Drawing Number **01S-107-649 THRU 668** Change Letter **C** Changed by **DMP/BRK**  
Change Description & Reason: **PART #01S-107-660 ONLY—**  
**ADDED 1" x 3/4" ANGLE CLEARANCE CUT**  
**AT UPPER END OF TROUGH.**

D	NAME	TROUGH	OWENS-ILLINOIS, INC.
E	C	IP-6-V	N.S.	OIS-107-649
F	P	CHANGES	CAST IRON ASTIN-MG	THRU 668

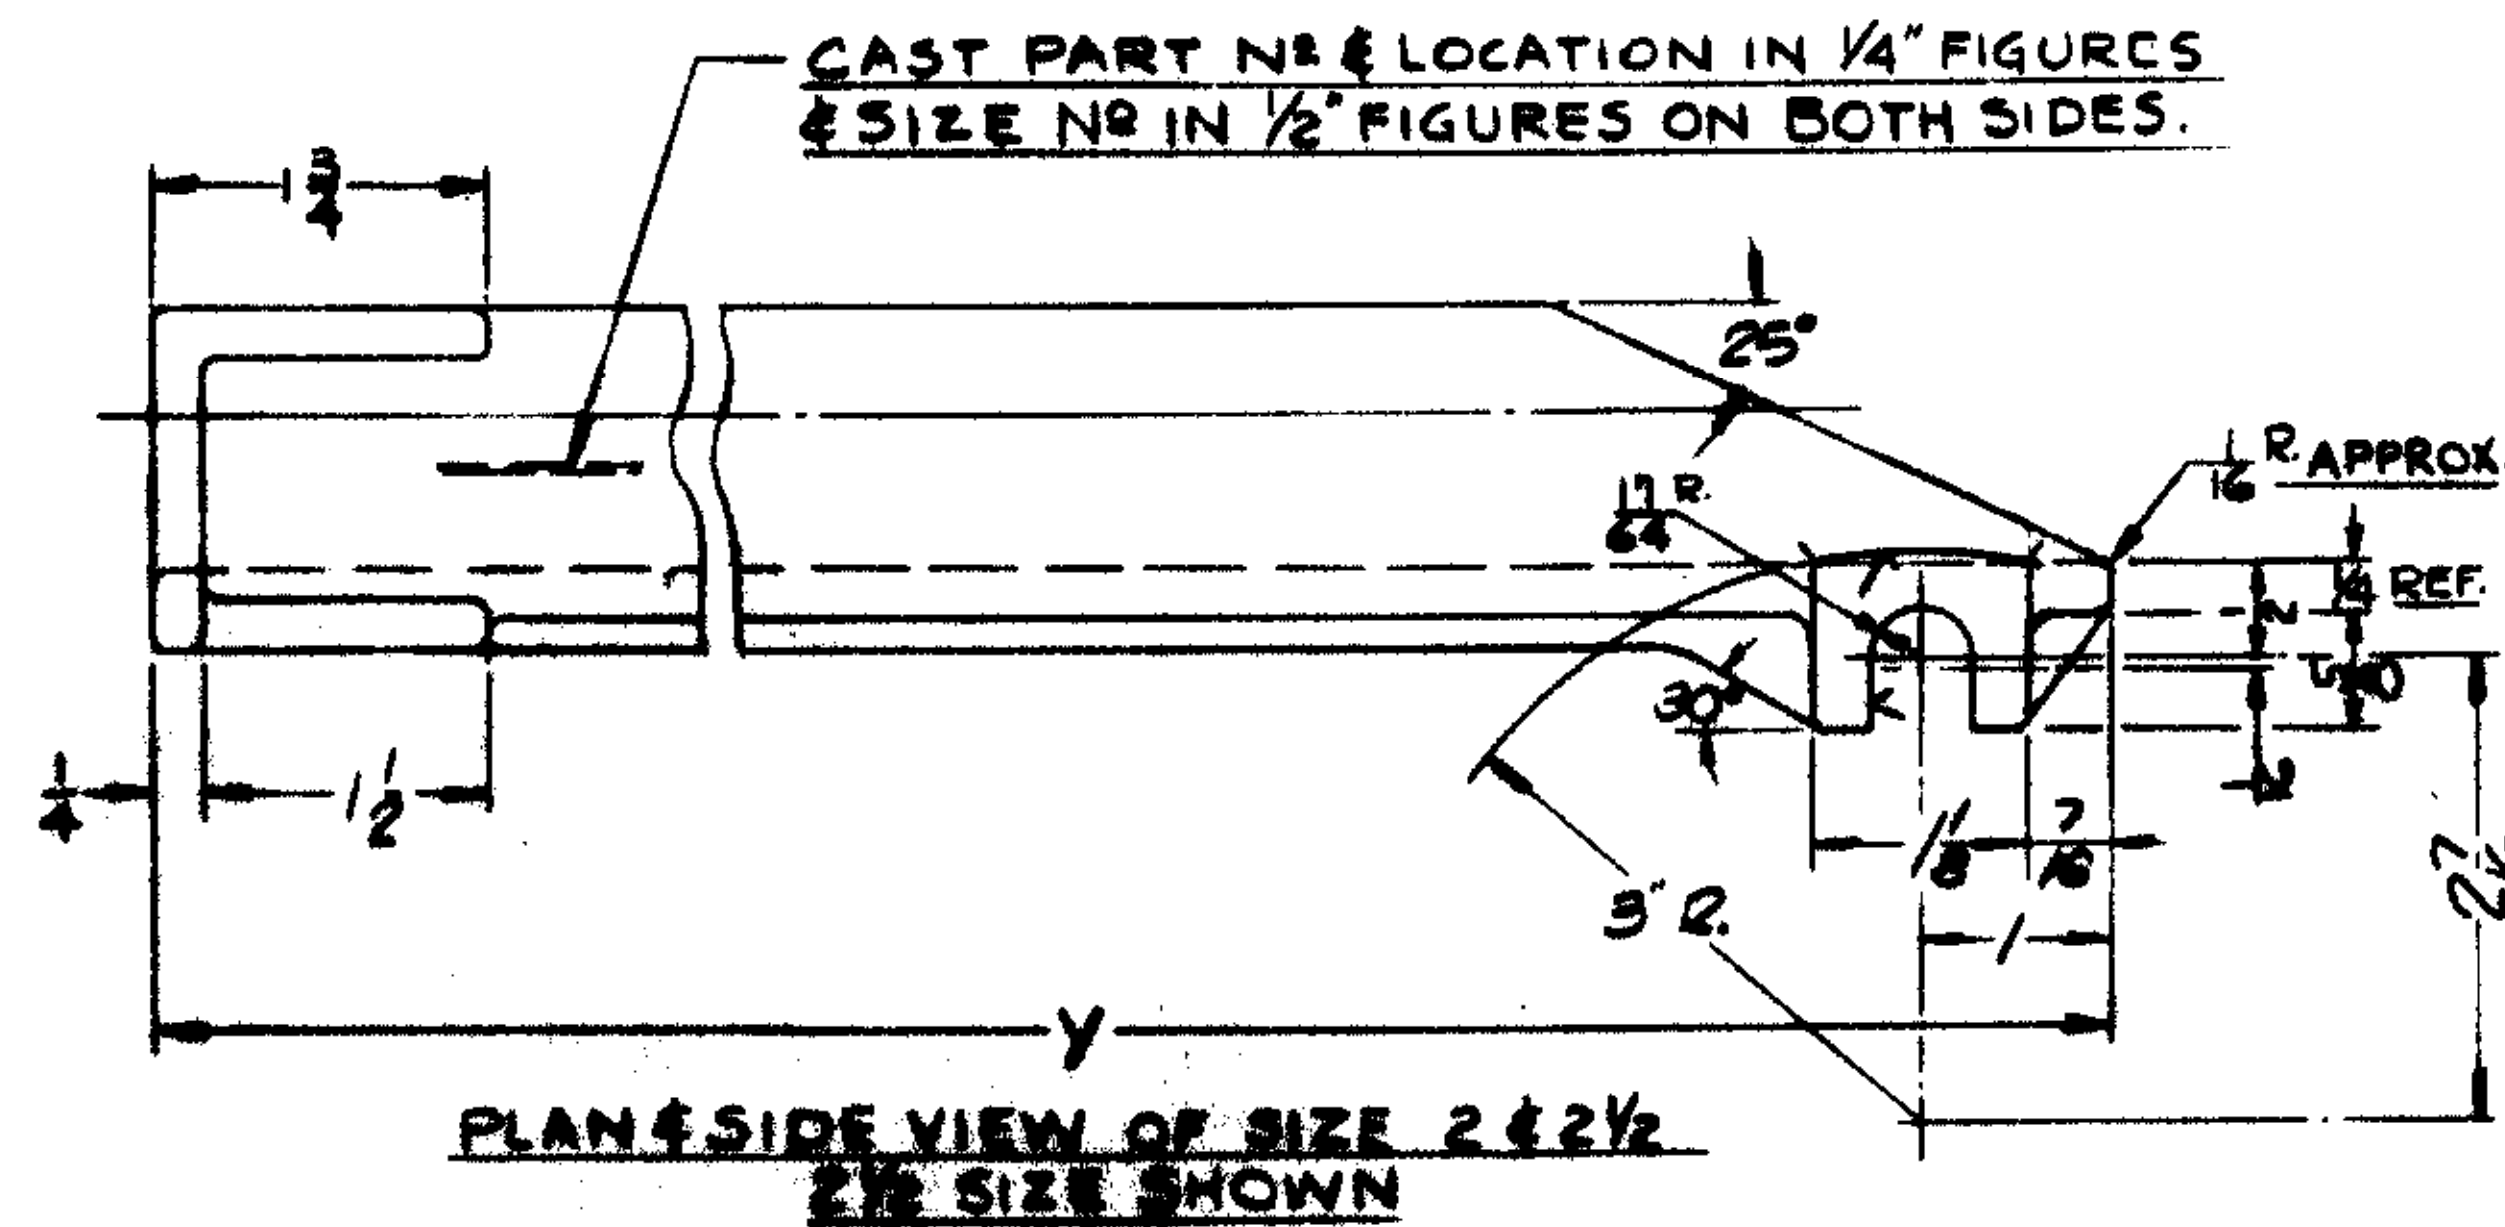
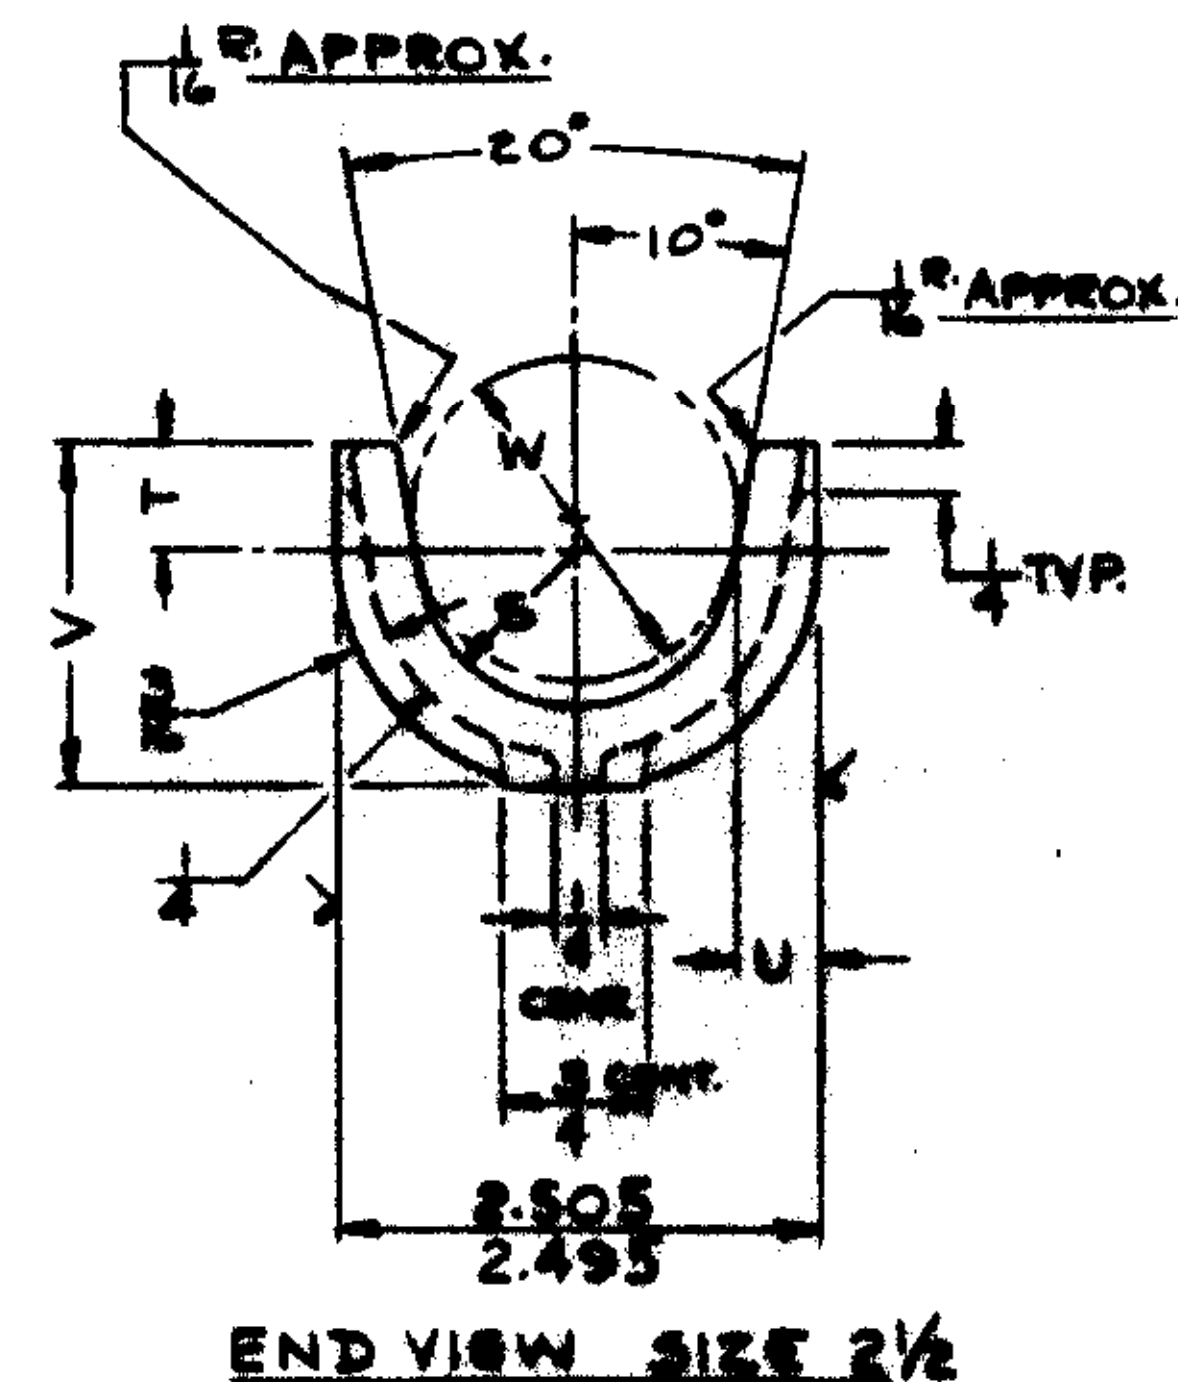
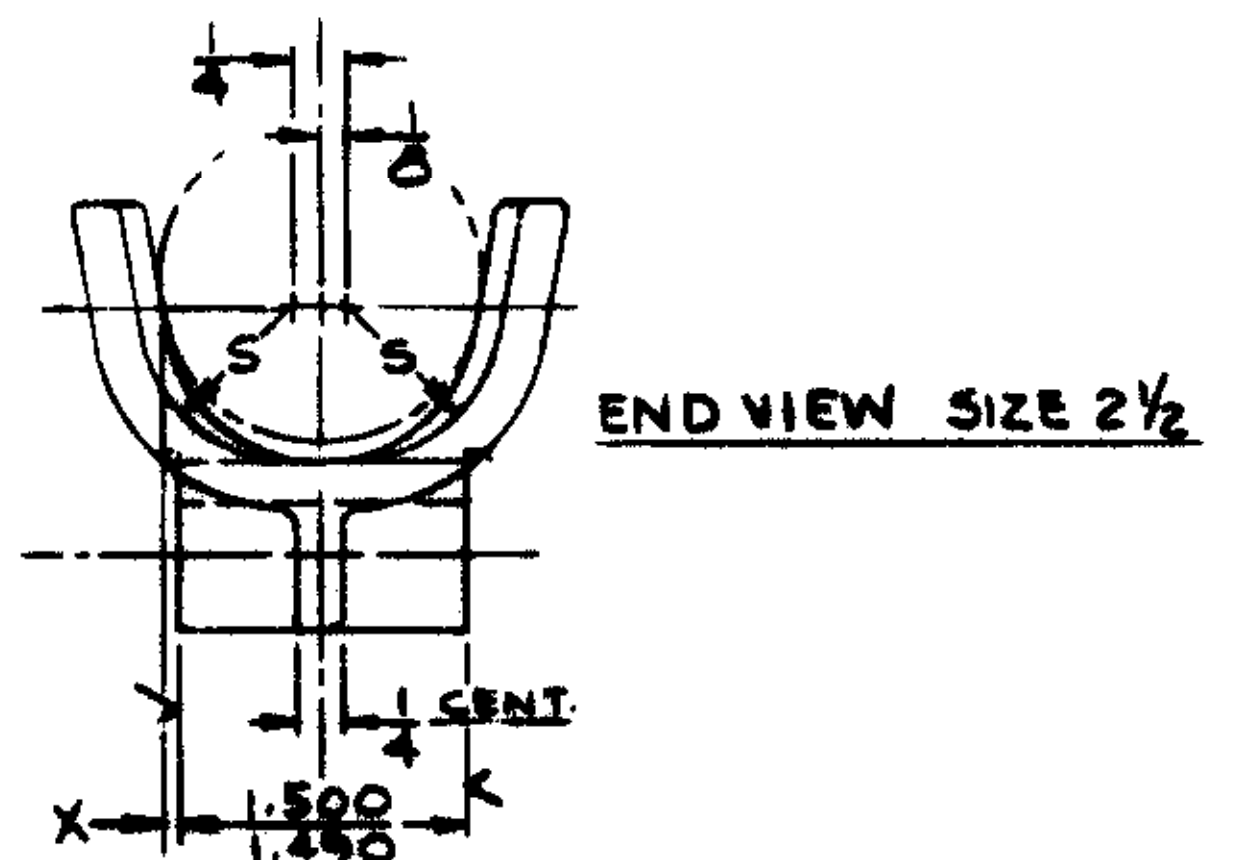
**INTERFERENCE.**
